Customer Product/Process Change Notification

PCN # 102409
 Issued Date: 03/02/2023
 Issued By: Cheryll Santiago
 Author: Cheryll Santiago

New LED Die material is higher luminous intensity

Old Part Drawin

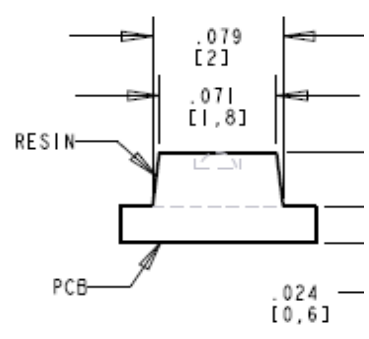
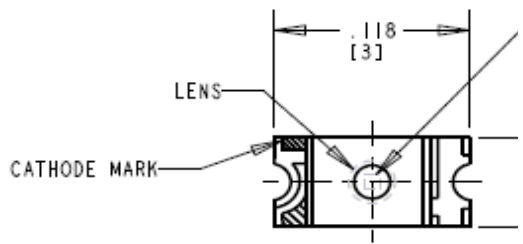
Package size is thinner 1.4mm vs old package size 1.5mm, Viewing angle on new part is 40 degree vs 70 degree
